Main gear leg sockets MG03P/S

Applicability: Components delivered between the beginning of December 2000 and the end of May 2001.

Fig 1. Main gear leg socket showing mounting hole.

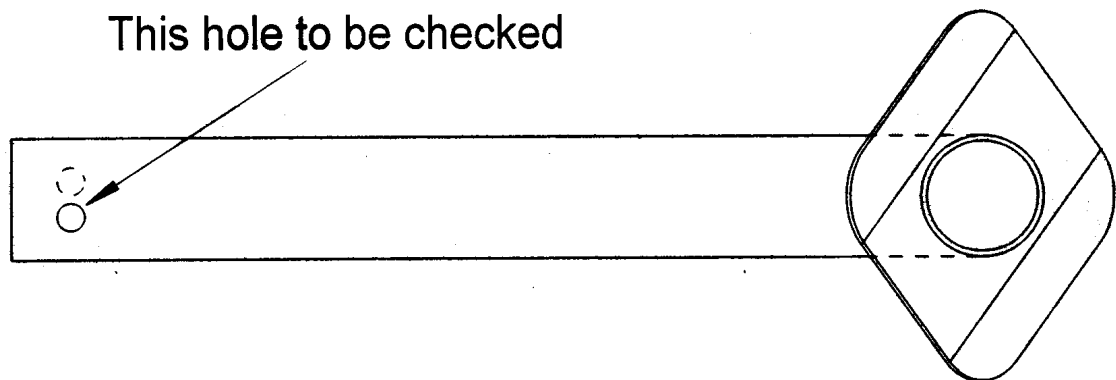
It has been established that a batch of components of the above part number included some which had the hole at the top drilled incorrectly, such that it did not line up with the equivalent hole in the main gear leg. Figure 1 shows a view of the socket and the hole concerned.

1. Trial fit the main gear legs to the sockets to establish whether the AN5-21A bolt will pass through both components.
2. If the components are defective, return them to Europa for free replacement.
